DEVELOPMENT CONSENT AUTHORITY PALMERSTON DIVISION

AGENDA ITEM: **1** MEETING DATE: 13 June 2025 FILE: PA2025/0106

APPLICATION PURPOSE: Dwellings-group (12 x 3 bedroom) in 6 x 1 storey buildings
SUBJECT SITE: Lot 11203 (5) Lind Road, Johnston, Town of Palmerston
ZONE: MR (Medium Density Residential)
SITE AREA: 3430m²
APPLICANT Tatam Planning Co. (Catriona Tatam)
PERSONS ON WHOSE - Landowner; and
BEHALF THE - Mr George Savvas
APPLICATION IS MADE
LANDOWNER Mr Jimmy Corfias
ANY PERSON WITH AN Nil
AGREEMENT TO ACQUIRE
AN INTEREST IN THE
LAND

Figure 4 – non-compliance

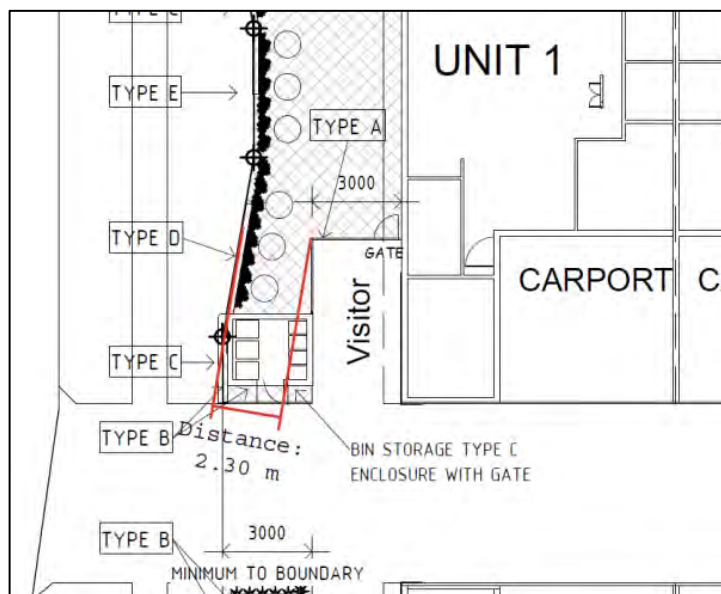
Sub-clause 6 of Clause 5.2.4.4 requires a car parking area to be at least 3m from any lot abutting a road.

All car parking spaces are set back 3 or more metres from the boundaries abutting a road with the exception to the 'visitor car park' located next to 'Unit 1' which is set back 2.3m (figure 4).

Administration-clause 3 allows the consent authority to *consent to a car parking area that is not in accordance with sub-clause 6 if it is satisfied that the non-compliance will not unreasonably impact on the amenity of the surrounding locality*.

Figure 5 – non-compliance

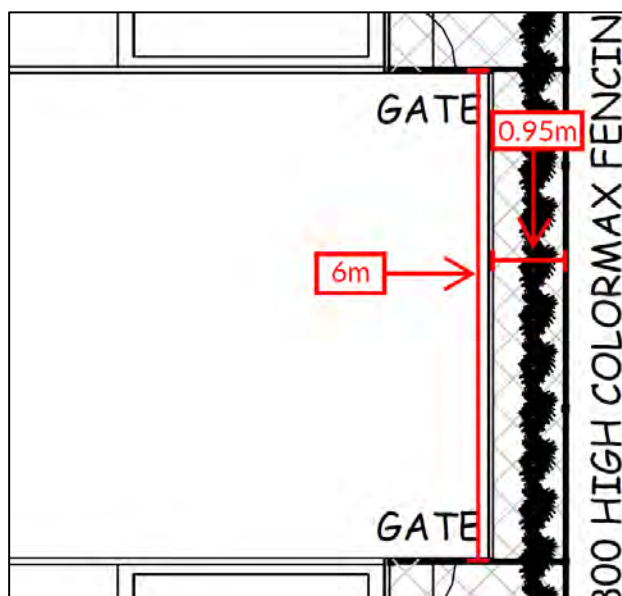
Approximately 0.95m (wide) of planting is proposed along the north side boundary at the end of the driveway. A solid metal fence (1.8m high) on the north boundary will provide screening. The section of landscaping that is non-compliant is only 6m long (see Figure 5).

It is noted, however, that the species chosen for most of the boundary have maximum heights of 1.5m. Although this is not expected to impact on the amenity of the streetscape, locality or adjoining properties, it is unlikely to provide adequate screening to the private open space areas.

It is also recommended that a condition is included on the permit that prior to the endorsement of plans, amended drawings are provided to show the locations of water meters and electricity meters for the proposed development.

Figure 6 – approximate position (coloured lines) of required building setbacks

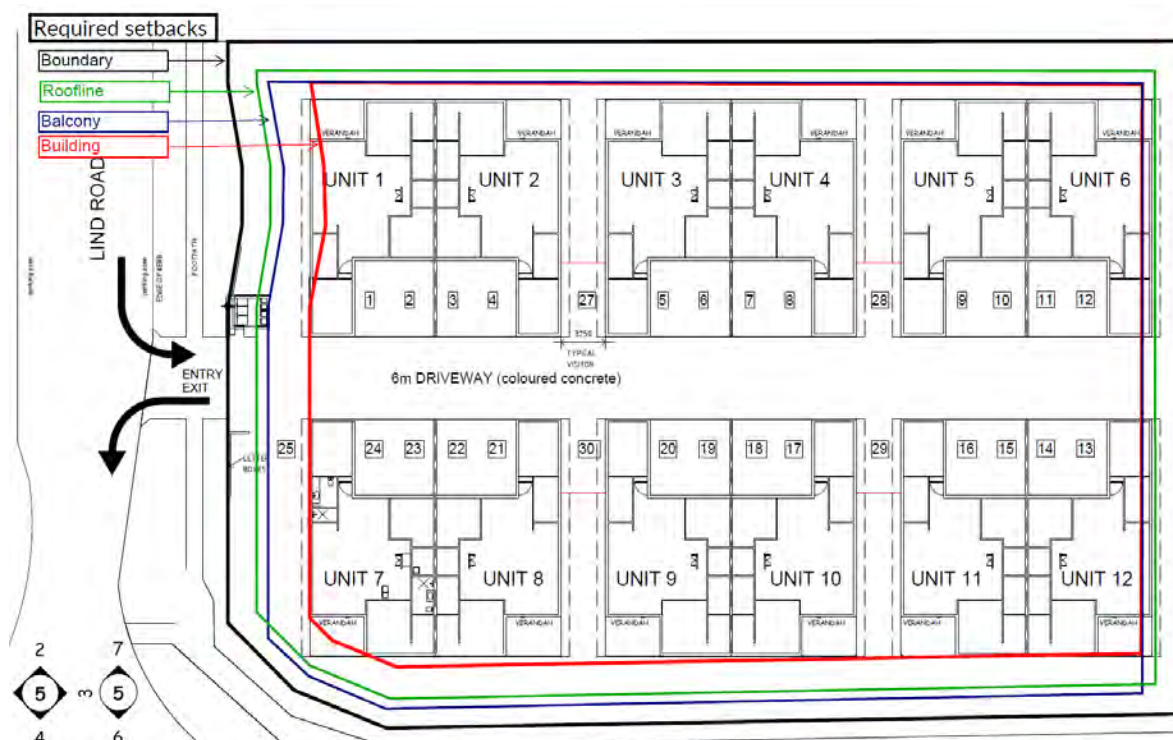
Sub-clause 6 of Clause 5.4.3 requires residential buildings and ancillary structures in Zone MR to be set back from lot boundaries in accordance with Table B to Clause 5.4.3.

Six “residential buildings” and (associated) ancillary structures are proposed, a detailed assessment of the building setbacks is provided in the table below and the (below – Figure 6) image shows the different setback requirements in relation to the proposal.

Figure 7 – Redline showing length of 1.5m high fence

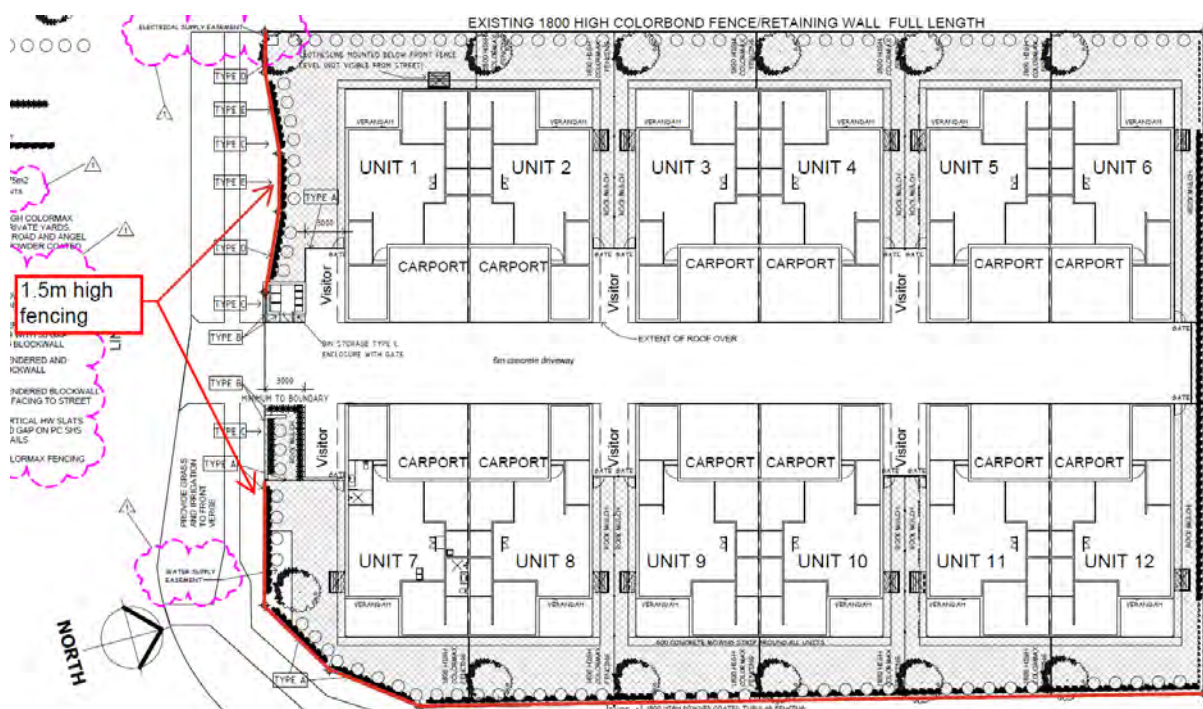
Sub-clause 3 of Clause 5.4.6.1 requires that for *dwelling-groups*, any private open space located at ground level is to be screened by either a screened fence to a height of 1.8m, or a fence to a height of 1.8m with dense vegetation that will provide a visual barrier to adjoining residences and public areas

The application proposes 1.5m high fencing between the primary and secondary street boundaries and the private open space of unit 1, and units 7 through to 12 (figure 7 below).

To ensure adequate private open space (privacy, delineation and screening) it is recommended that amended plans are provided prior to endorsement of plans to amend the landscaping to include screen fencing to the height of 1.8m or to provide landscaping that will grow to a height of 1.8m or more and that will provide a visual barrier within 2 years of planting.
